# Conceptual Review Agenda

Schedule for 03/25/13 to 03/25/13

# 706 E Stuart Therapeutic/Transitional Housing

**Re: 706 Stuart - Therapeutic/Transitional Housing**

SITE PLAN FOR  
1319 WEST PLUM STREET  
FORT COLLINS, COLORADO

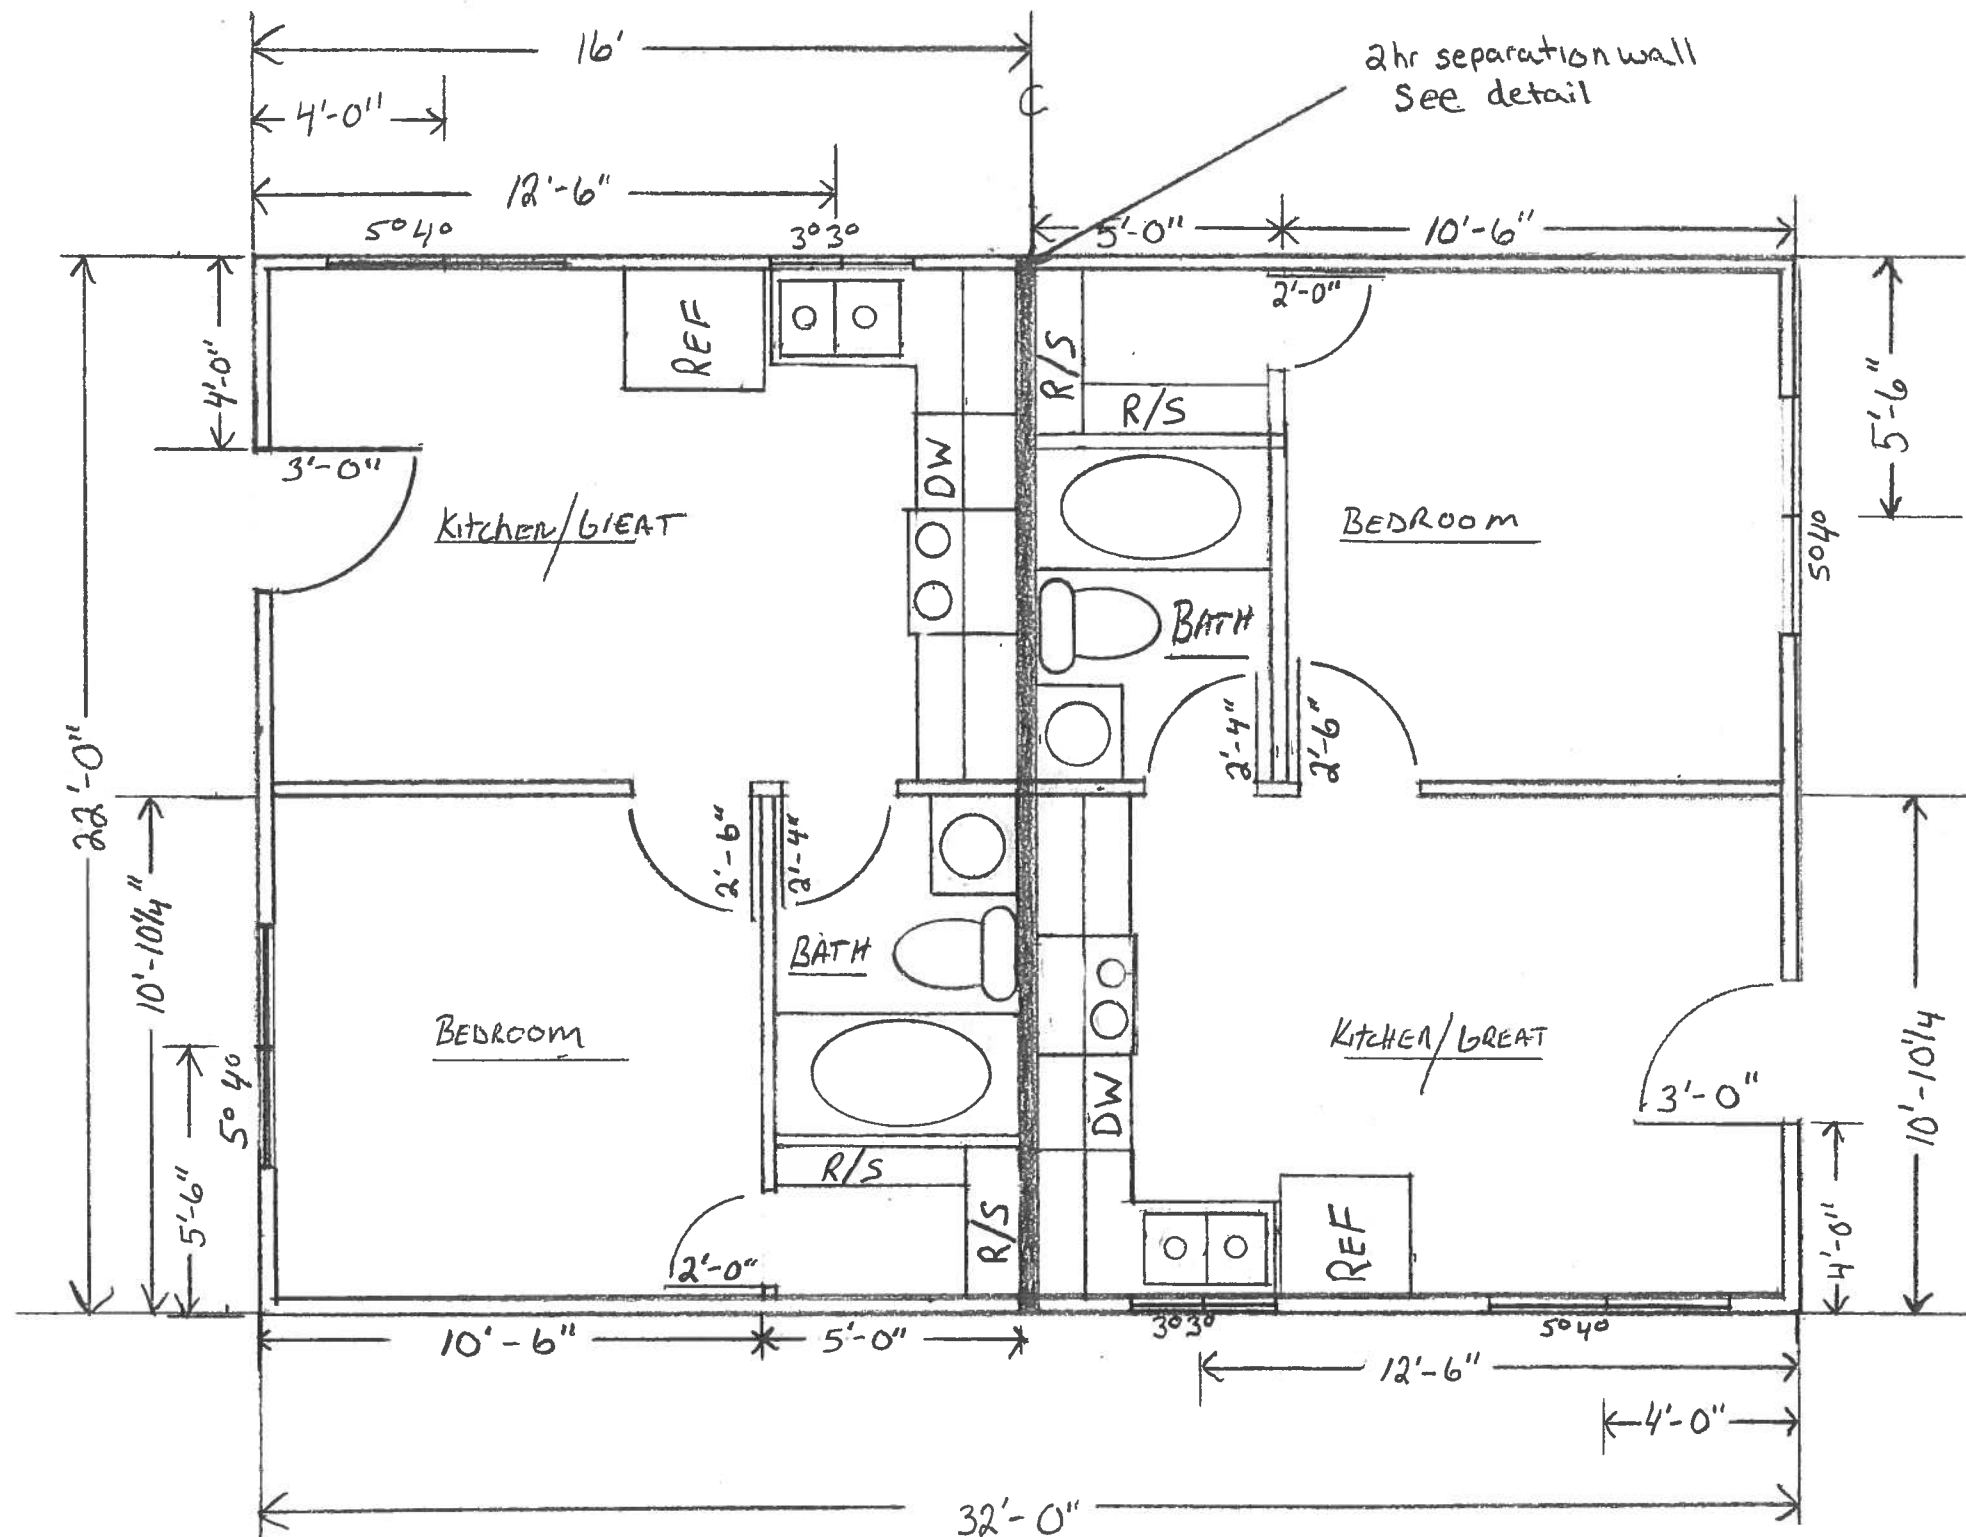
It is unclear what is being purposed because the application states the demo of the existing duplex and building of a new duplex but the site plan shows half the existing duplex remaining.

If half of the existing duplex remains this would be considered a Single family home which is not a permitted use in this zone district and would require an Addition of Permitted Use which is a Type 2 (Planning and Zoning Board) review.

3. LUC 3.2.2(K)(1)(a) Two-Family dwelling with one bedroom per unit shall provide 1.5 vehicle spaces per unit. This is a total of three required spaces for the project. If the spaces are not lined with a curb and gutter then wheels stop are required.

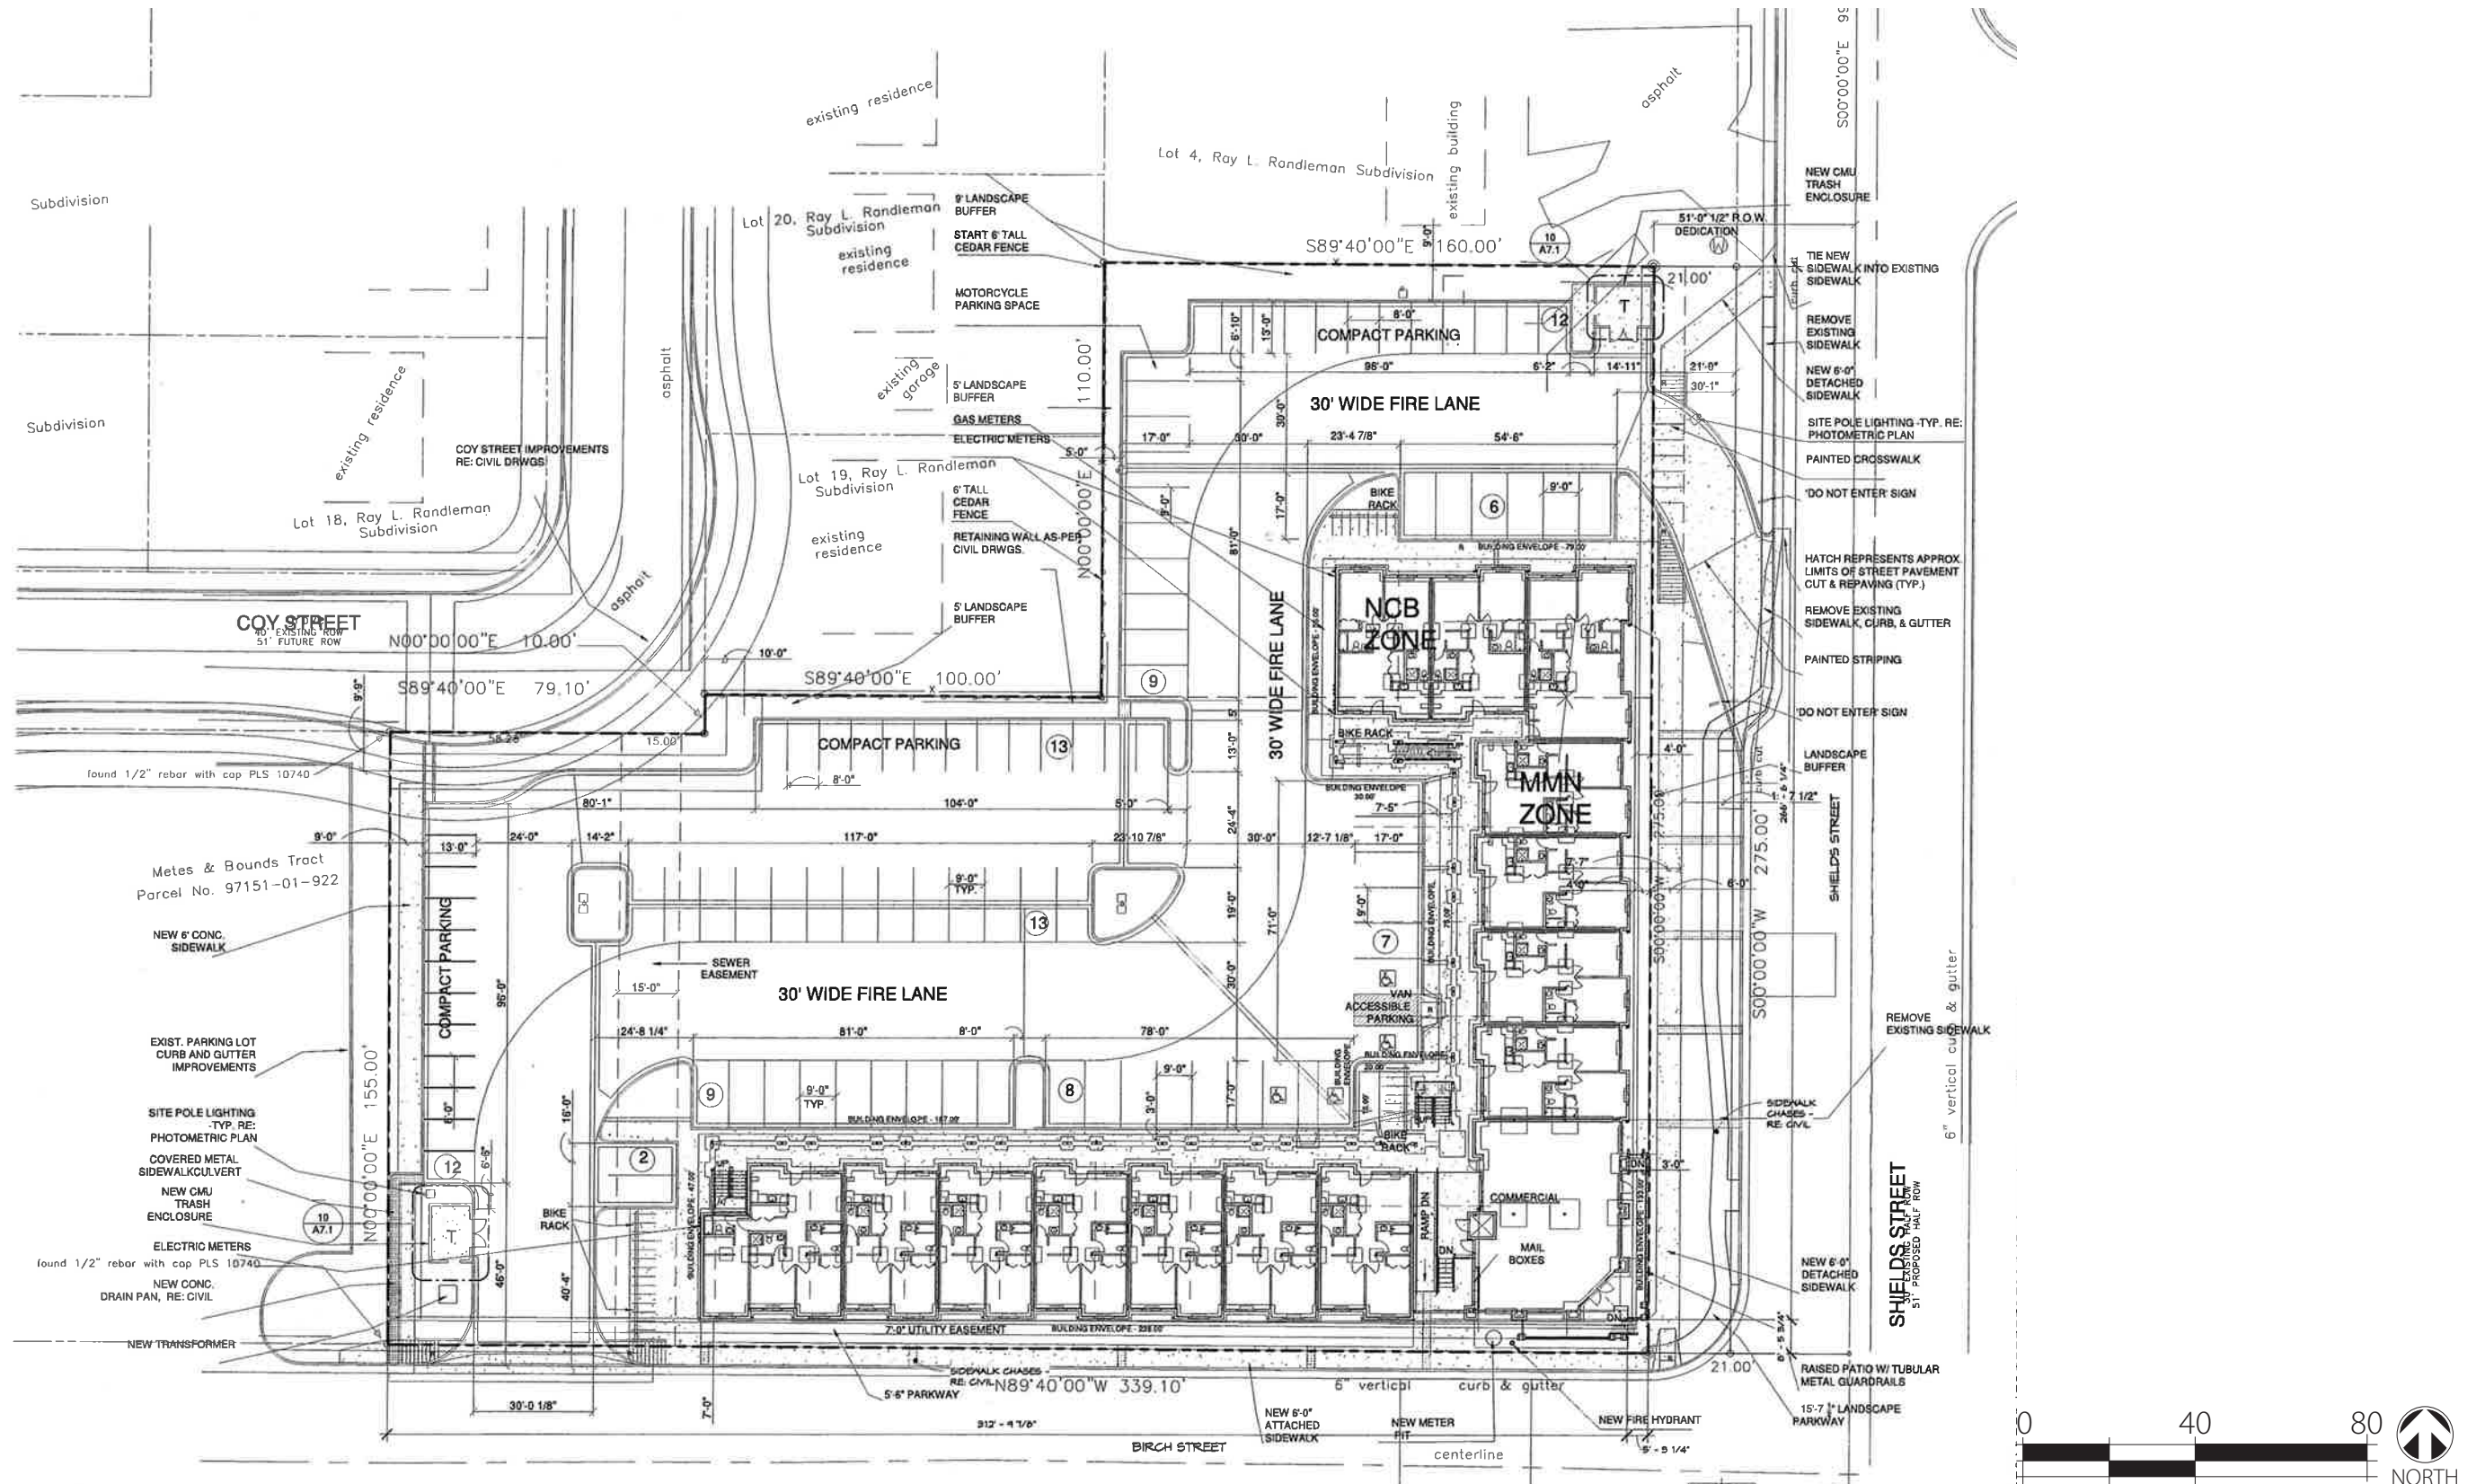
5. LUC 3.2.2(K) In the NCB zone district with four 3-bedroom units and one 2-bedroom unit a minimum of 10 vehicle spaces are required only 40% can be compact. For the 1300 square of standard restaurant maximum of 13 vehicle space non are to be compact. Compact spaces shall be designated with a sign as reserved for employee or resident parking. The proposed plan is over on the allowed compact spaces.

LUC 3.2.2(K) In the MMN and TOD overlay districts the parking for 300 square feet of café maximum is three vehicle spaces non are to be compact. For the residential portion there is no maximum or minimum, however when providing any parking only 40% can be compact. Compact spaces shall be designated with a sign as reserved for employee or resident parking. The proposed plan is over on the allowed compact spaces.

11. Right of way for Coy Drive was dedicated with Hellenic Plaza subdivision and appears to be in conflict with the proposed site plan. This right of way also has a 9' utility easement that exists on the back of it.
